Access Compliance Report

Public Rights-of-Way

(Curb Ramps)

Intersection ID: 4649	Main Street: BLUE_ASTER_LN	Cross Street: CHASEWIND_DR	Location:	N
ADA ID: 28B93D9B2B46	Ramp Type: Perp	Initial Pass/Fail: Fail	Overall Compliance: No	Severity Score: 13.75
Codes/Mitigation Info/Possible Solution		Field Measurements/Component Compliance

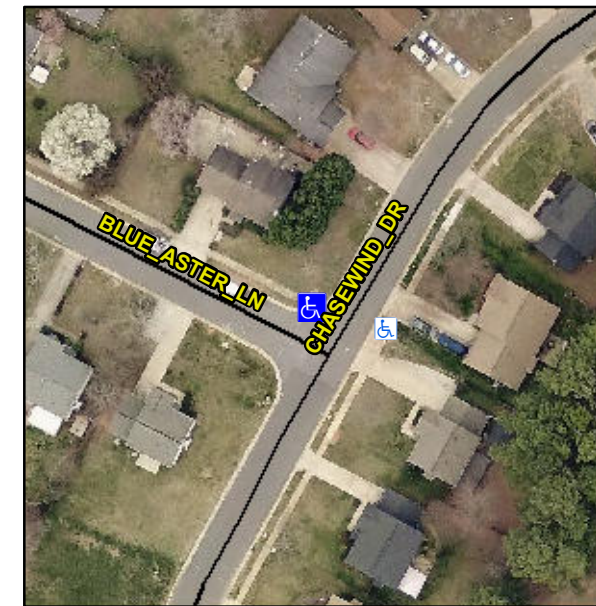
Not Found, R304.2.2, R304.5.3

Compliance	Description	Data	Compliance	Description	Data
N/A	Ramp Length (in)	51.0	No	Ramp Slope (%)	8.8
Yes	Ramp Width (in)	48.0	No	Ramp XSlope (%)	2.2
N/A	Flare Type LT	N/A	N/A	Flare Type RT	N/A
N/A	Flare Slope LT (%)	N/A	N/A	Flare Slope RT (%)	N/A
N/A	Flare Traversable LT?	N/A	N/A	Flare Traversable RT?	N/A
N/A	Landing Length (in)	N/A	N/A	DWS Provided?	N/A
N/A	Landing Width (in)	N/A	N/A	DWS Contrast?	N/A
N/A	Landing Slope (%)	N/A	N/A	DWS Length (in)	N/A
N/A	Landing X Slope (%)	N/A	N/A	DWS Full Width?	N/A
N/A	Landing Curb? (Y/N)	N/A	N/A	DWS Offset (in)	N/A
N/A	Shared Landing?	N/A			
N/A	Gutter Ponding?	N/A	N/A	Gutter Slope (%)	N/A
N/A	Gutter Lip Ht (in)	N/A	N/A	Gutter X Slope (%)	N/A
N/A	Painted X Walk1?	No	N/A	Painted X Walk2?	N/A
	X Walk 1 Direction	To SE		X Walk 2 Direction	N/A
N/A	X Walk 1 Width (in)	N/A	N/A	X Walk 2 Width (in)	N/A
	X Walk 1 Slope (%)	7.0		X Walk 2 Slope (%)	N/A
	X Walk 1 X Slope (%)	0.8		X Walk 2 X Slope (%)	N/A

Remove & Replace Entire Ramp.
